The Sandstone Precinct: MOD 7 Design Report

Document Number
SP-RPT-E-MAKE-0005

MOD 7 Design Report

Column setting out

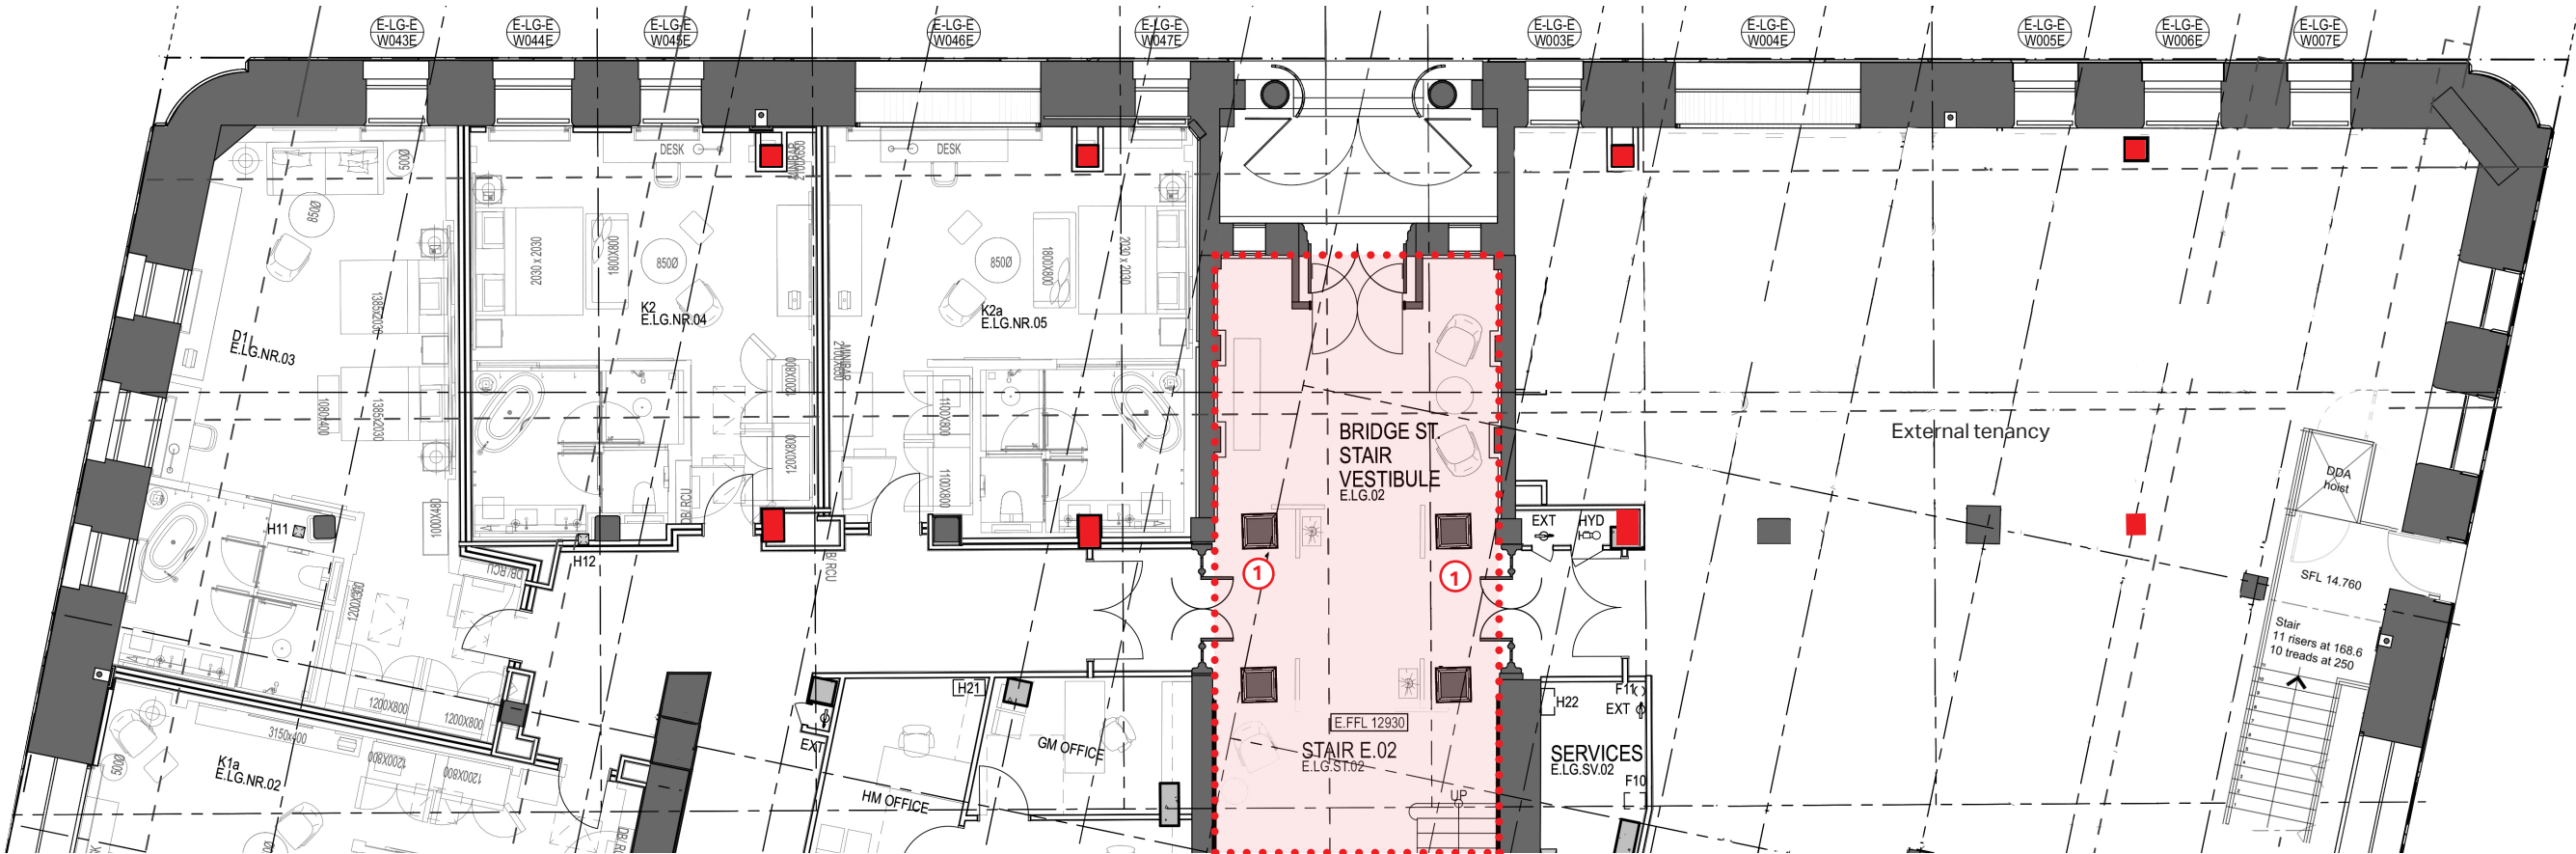
- 1. The eight new columns on each level remove the requirement for column strengthening to the existing marble clad columns and footings in the Bridge Street heritage vestibule.

Column setting out

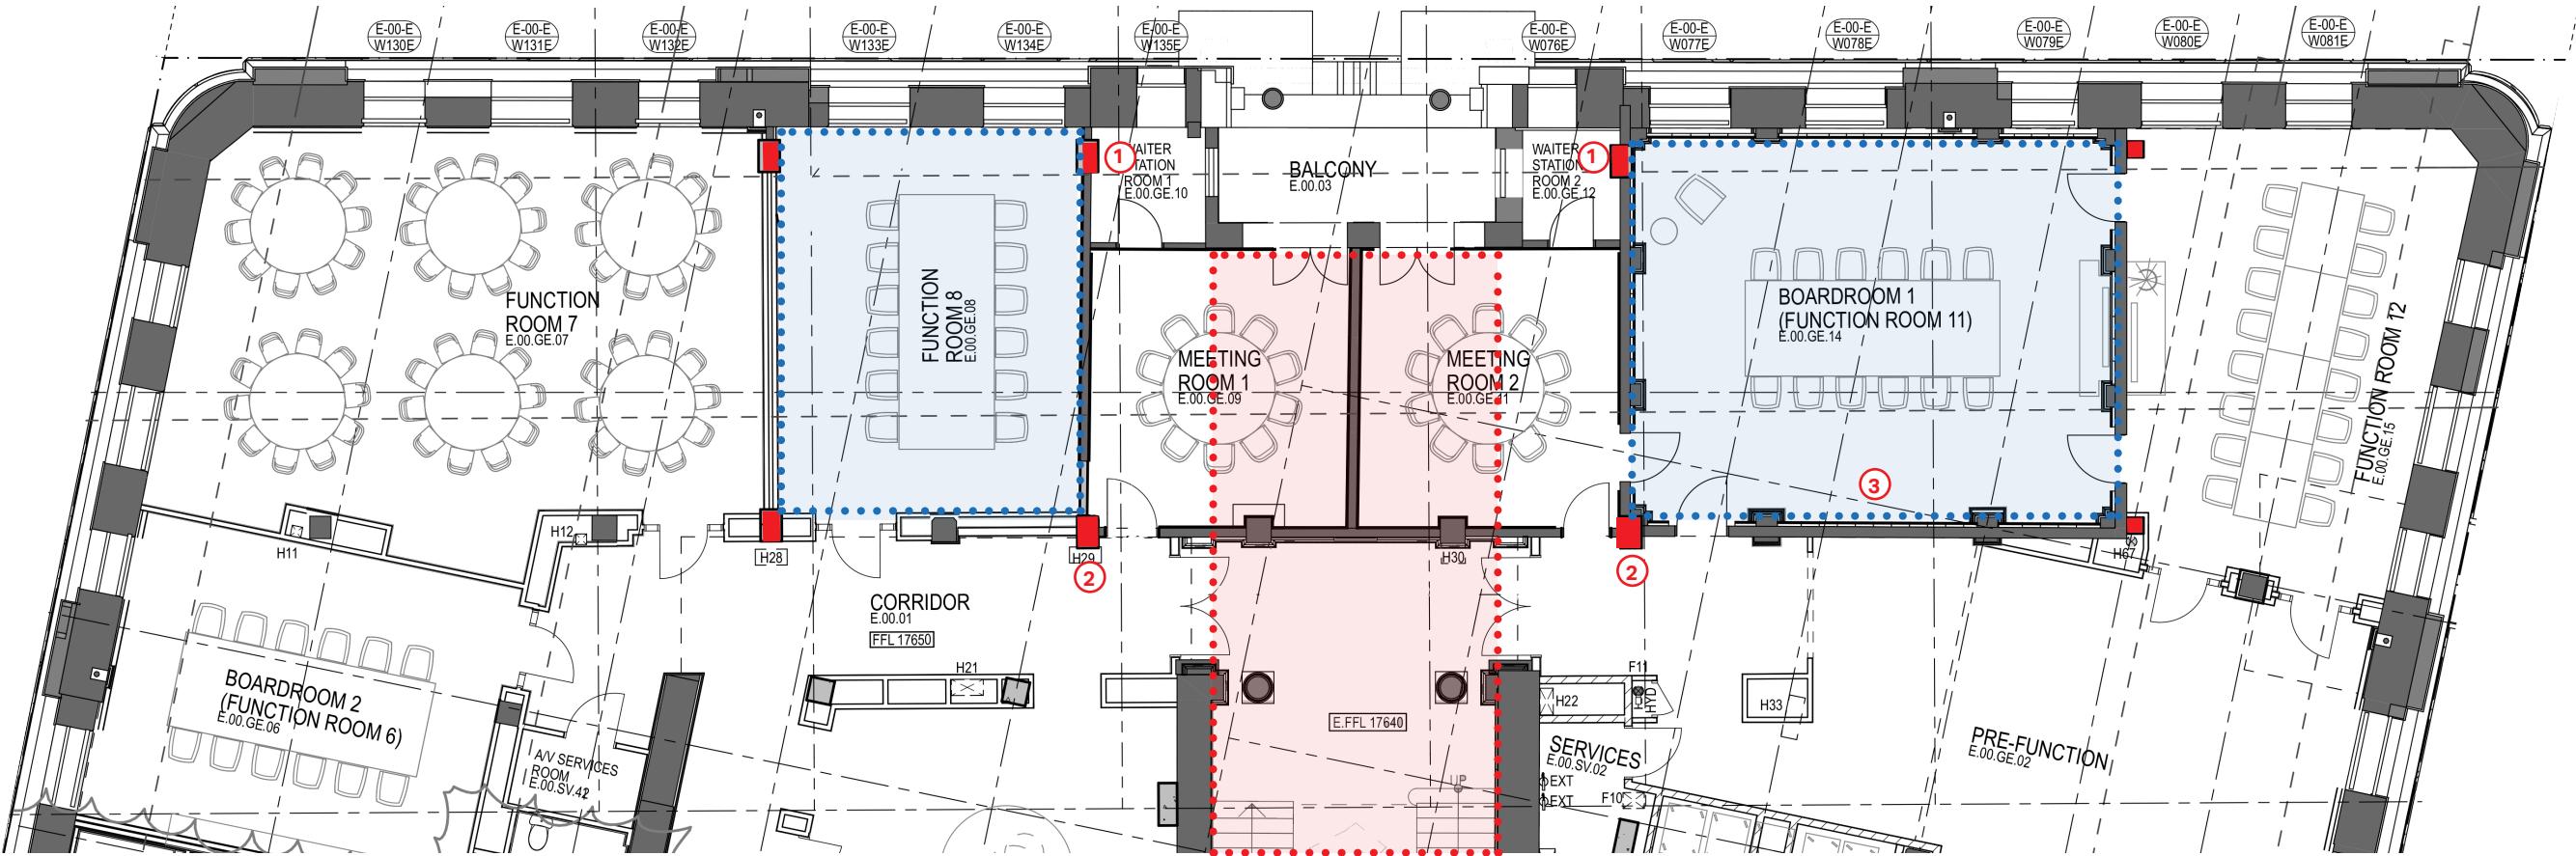
- 1. Columns located within BOH waiter station room to avoid heritage fabric. No existing heritage ceiling within this space.
- 2. New build outs have been introduced which mimic the existing fabric to conceal the new pool columns. Width of new column cladding to match existing nibs/ columns in corridor. The symmetry of the existing heritage corridor is maintained.
- 3. The eight new columns on each level remove the requirement for column strengthening to the existing timber clad columns

Column setting out

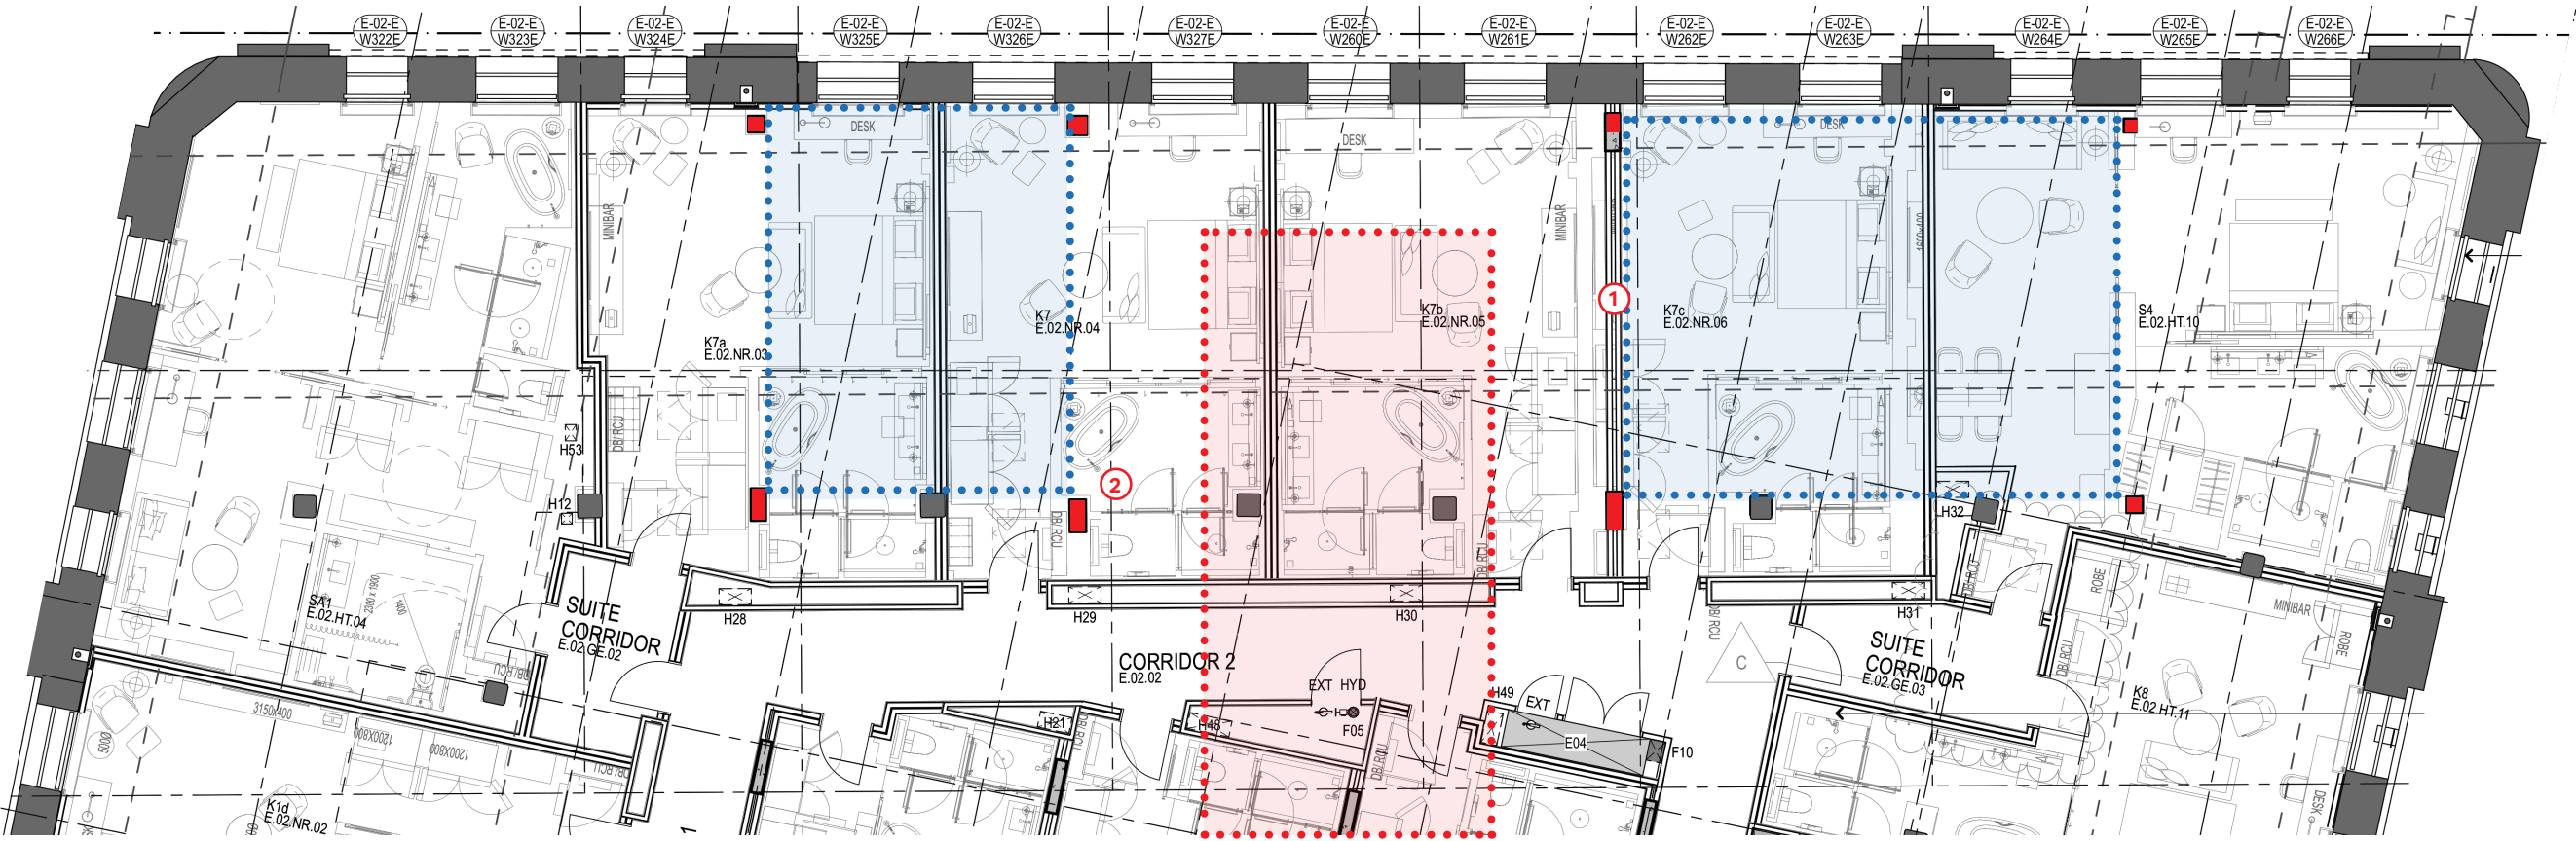
- 1. Columns have been located within intertenancy walls where possible to conceal.
- 2. New columns which are not within the intertenancy wall build up have been concealed within ID joinery elements

Level 5 Gym

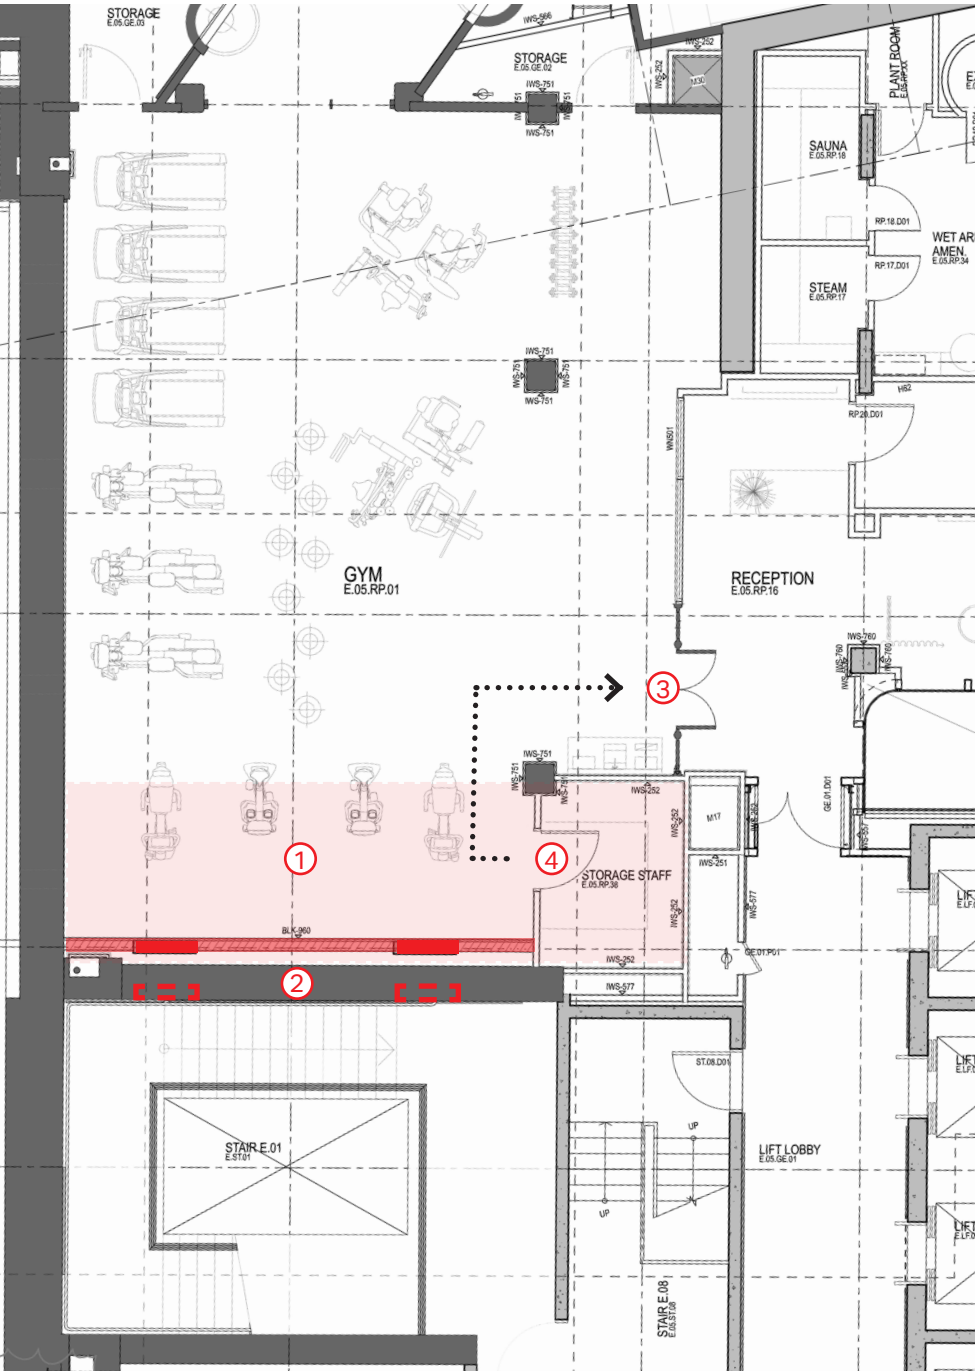
- 1. Amenity of gym improved by raising the floor level in zone highlighted in red. This removes the requirement for a stair within the gym area. Implications to the existing heritage doors (noted in 3)
- 2. The original proposed location of new columns in the existing wall (dashed red line) was further developed and deemed a safety risk due to the instability of the existing heritage wall. The layout has been updated to move the columns and new wall north. The existing heritage wall remains in place (shown in grey)
- 3. Heritage door relocated to become entry door into gym.
- 4. New wall and concealed door added to close off storage space
- 5. Heritage cornice rebuilt further north to match existing detail and align with new wall and column location

Proposed relocation of door: Gym entrance

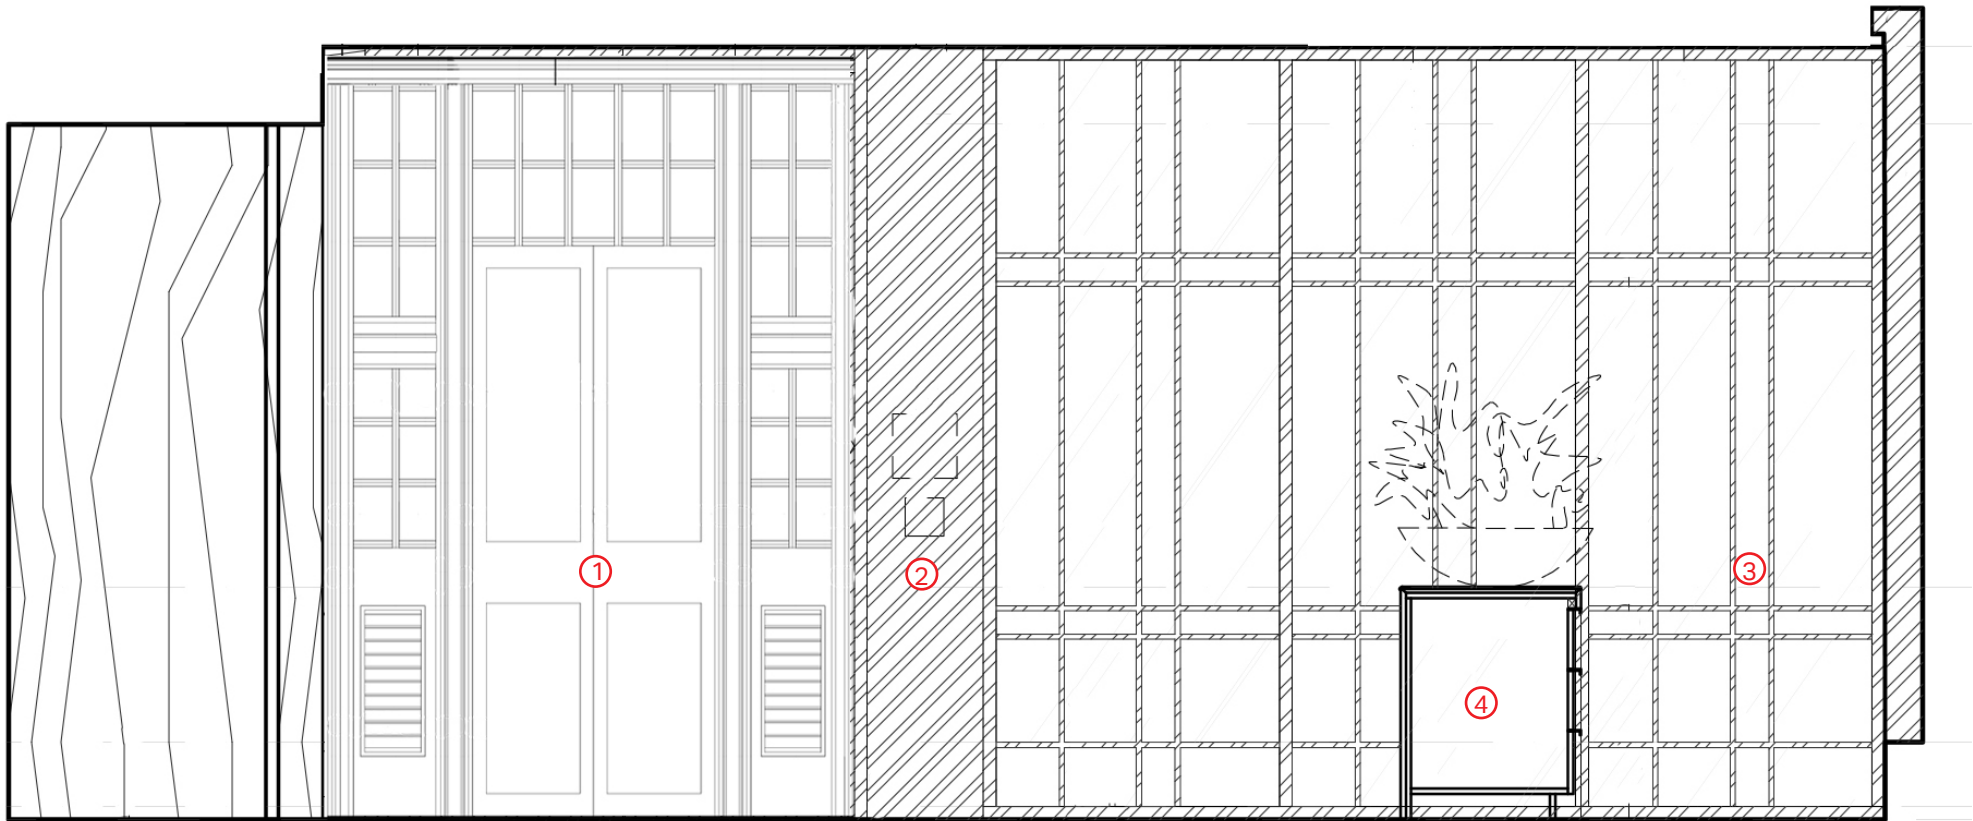
- 1. Heritage door modified and relocated to become entry door into gym.
- 2. Black metal wall panel with key card reader for access to gym
- 3. Full height glazed partition-clear glass with black metal frame. Glazing break up to be further developed to relate to the datum's of the relocated heritage door
- 4. Spa reception counter
- 5. Top panel of existing heritage fanlight to be carefully removed and stored in the heritage store
